5-9 Cowan Road St Ives SSDA Landscape Report - Response to Submissions

Prepared for Prosper
June 2026

DPHI Comments to RtS

Masterplan

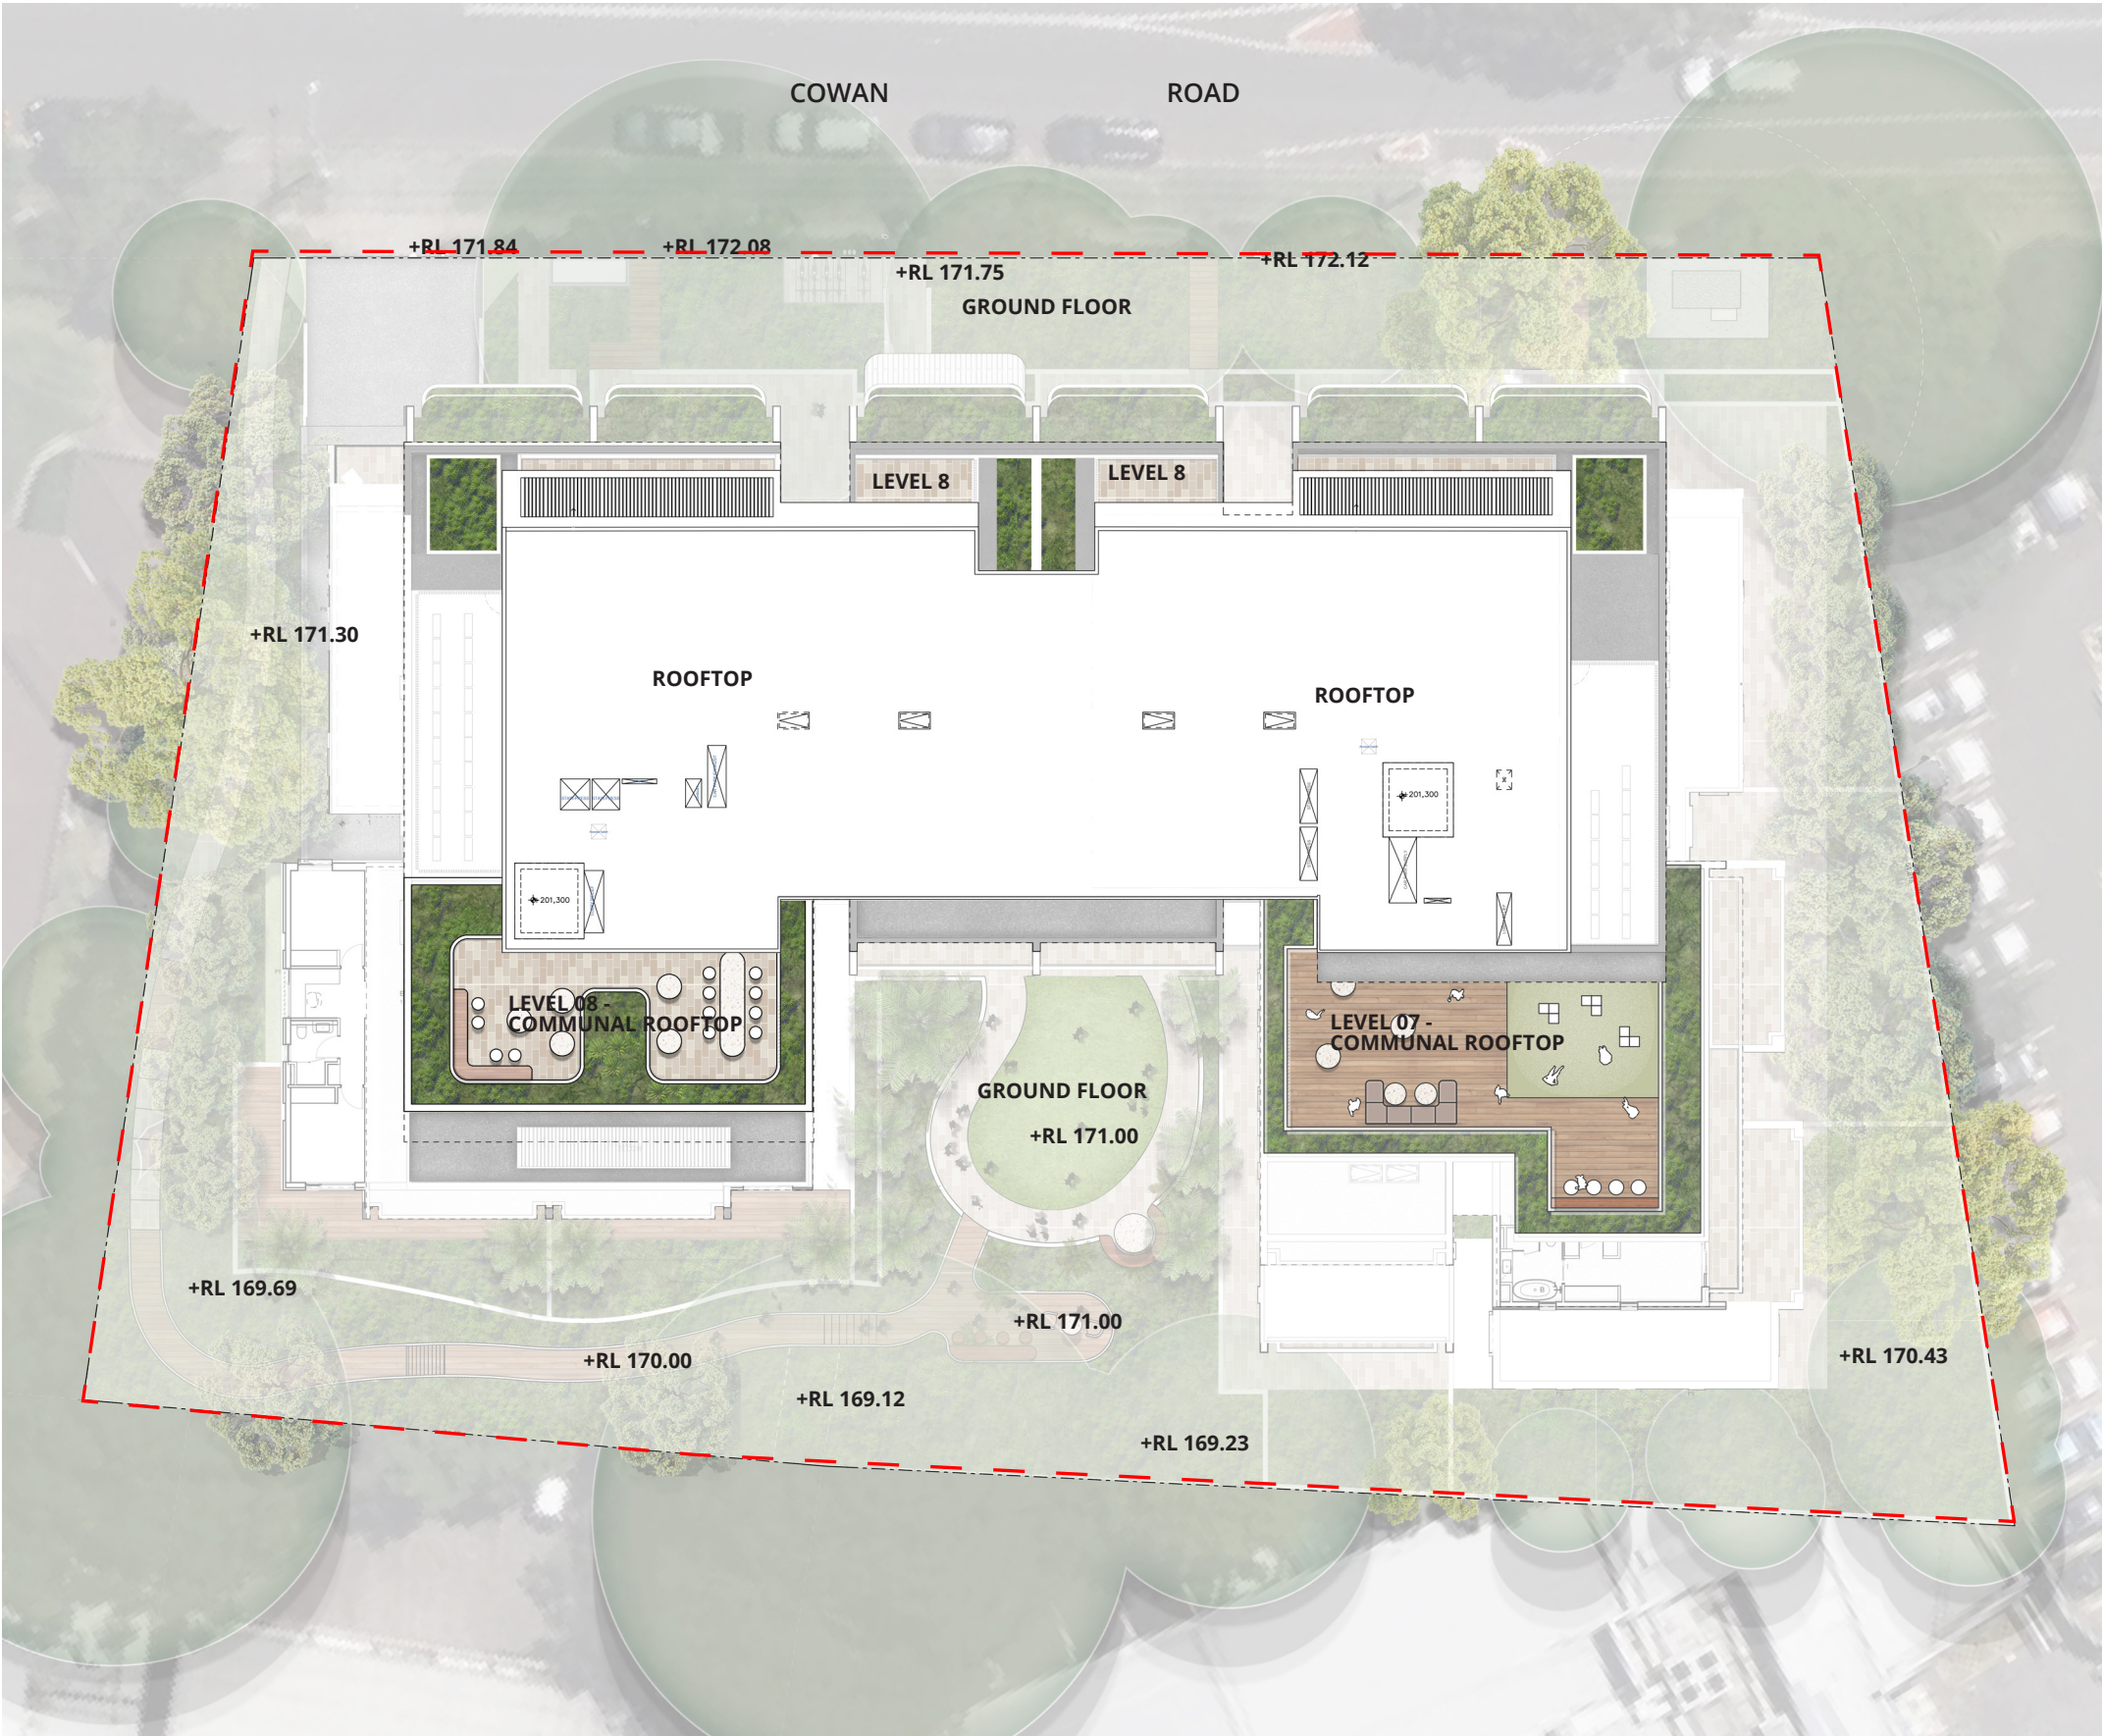
The response to DPHI letter states ‘Adjustments to OSD tank size and location due to existing sewer and stormwater easements’ Ensure the Architectural plans/stormwater plan reflect this change.

Revise proposed landscape planting within the sight triangles adjacent to the driveway to increase pedestrian safety. Amend the traffic report to confirm no issues with plant species selected in the sight triangles.

Arcadia Comments: The planting design adjacent to the on-site detention (OSD) tank was reviewed and updated in the previous revision as part of the amended landscape plan.

One tree previously proposed above the OSD tank has been removed to avoid conflicts with underground infrastructure. The remaining two proposed new trees adjacent to OSD tank are *Lagerstroemia indica* (Crepe Myrtle). Their locations are outside the OSD tank footprint and do not conflict with the tank or associated services.

Refer to Pg. 16 Masterplan Ground Floor and Pg. 36 Tree Removal and Replacement Plan.

Arcadia Comments: Planting adjacent to the driveway was reviewed. Planting within the sight triangle has been removed to maintain clear sightlines and improve pedestrian safety and visibility.

Dianella caerulea (DC) is proposed outside the driveway sight triangle, as it typically grows to approximately 500mm in height and is suitable for maintaining visibility requirements. Its character also complements the landscape setting and arrival experience at the entry.

Refer to Pg. 16 Masterplan Ground Floor and landscape documentation package.

Ground Floor Comparison

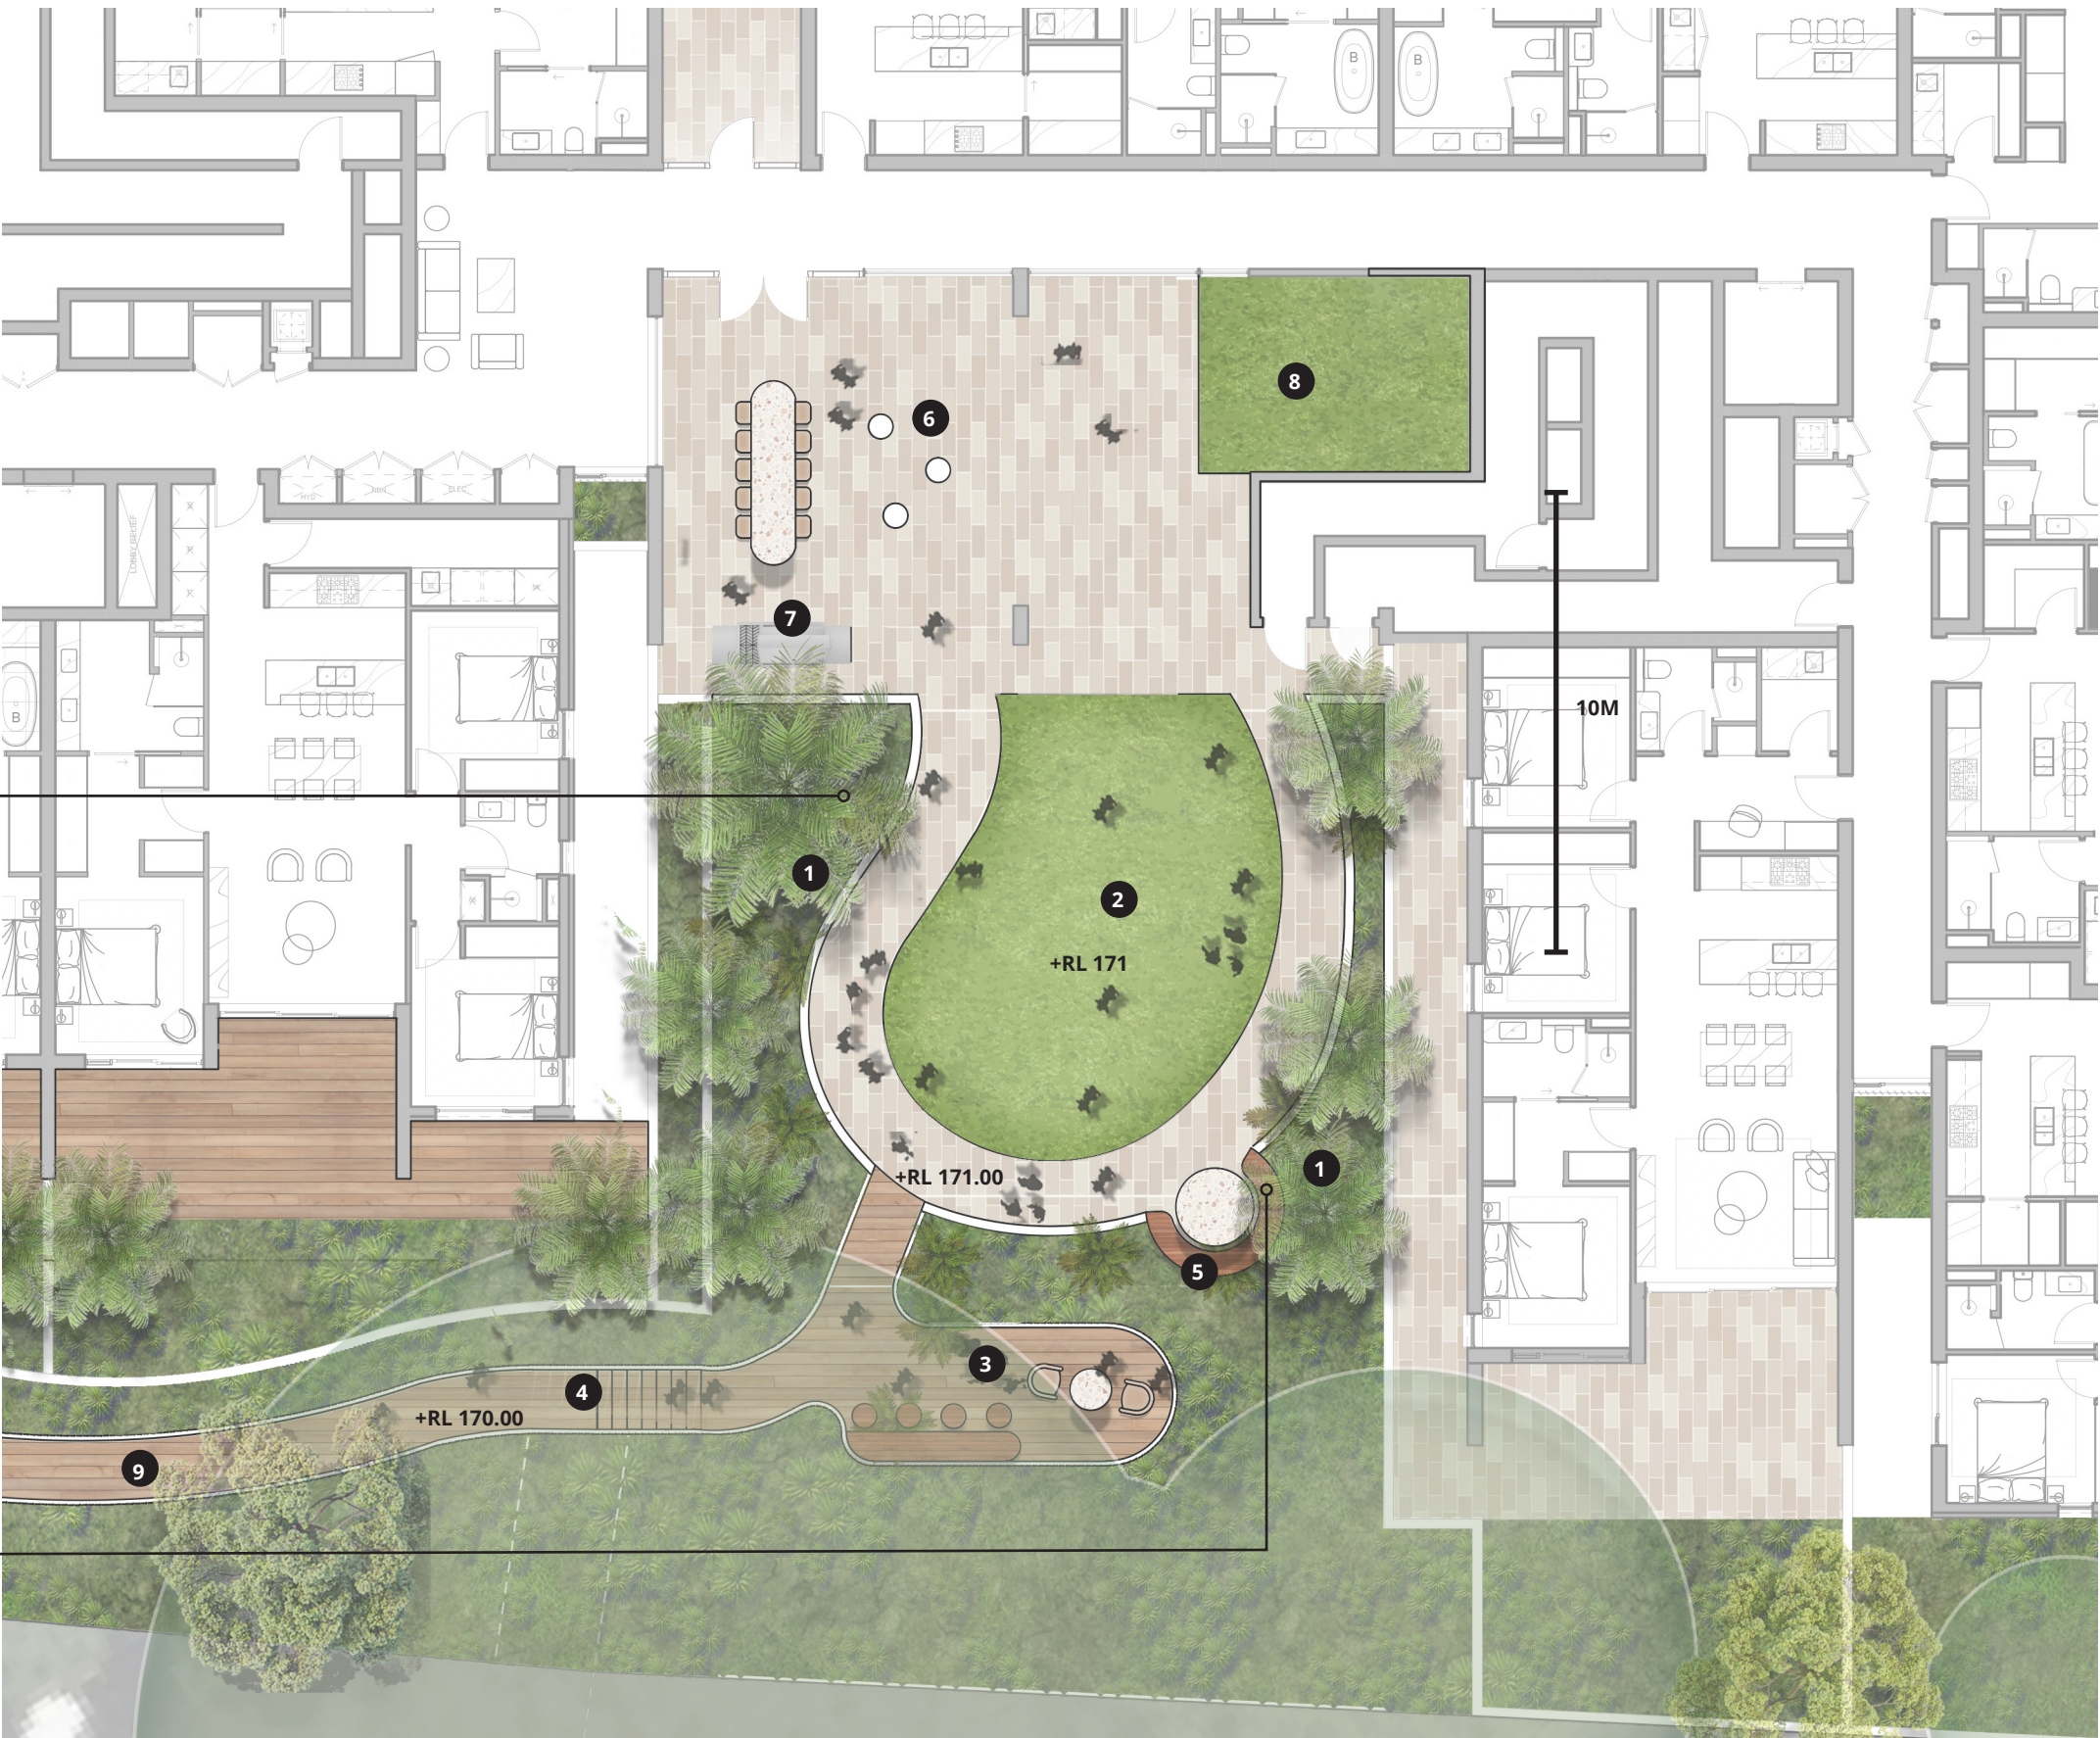
Revise the ground floor architectural plans against the landscape plan, as there is inconsistency between the location of paving, decking and landscaped area.

Arcadia Comments: The ground floor architectural plans and landscape plans have been coordinated and updated to ensure full consistency in the location and extent of paving, decking and landscaped areas across all documentation.
